Rezoning Transportation Analysis
Petition Number: Insert Zoning Petition #2021-195
General Location Identifier: 20105108, 20105106

Revision Log:	Date	Description
	12-28-2021	First Review (PDM)
	01-27-2022	Second Review (KP)
	02-21-2022	Third Review (KP)
	04-12-2022	Fourth Review (KP)
	04-27-2022	Fifth Review (KP)

General Review Information

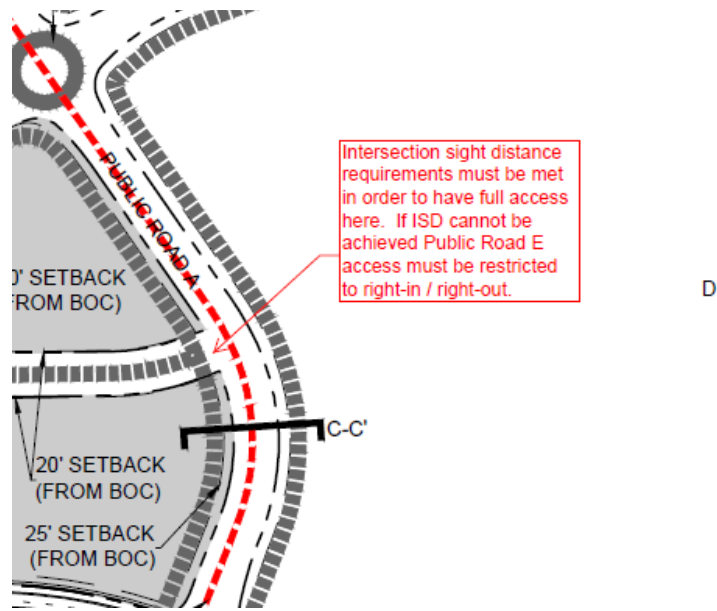
3. ~~**Comment Resolved with easement dedication to Mecklenburg County Parks and Recreation. Outstanding Comment from 12-28-2021:** Revise site plan and conditional note(s) to commit to construct an 8-foot planting strip, and 12-foot sidewalk on the entire property frontage of Arrowwood Road per Chapter 19 and Chapter 20. The site plan shall label and dimension both items from the back of curb and gutter and road centerline. The 12ft multi-use path also meets the council adopted Charlotte WALKS and Charlotte BIKES policies.~~

6. ~~Streetscape, Landscaping and Buffer:~~

- a. ~~**Arrowwood Road.** A thirty (30) foot setback as measured from the existing back of curb of Arrowwood Road will be provided in Development Area A. A twelve (12) foot sidewalk and minimum eight (8) foot planting strip will be provided along the portions of Arrowwood Road that are being widened because of road improvement requirements. The existing five (5) foot sidewalk is to remain outside of those road widening areas.~~
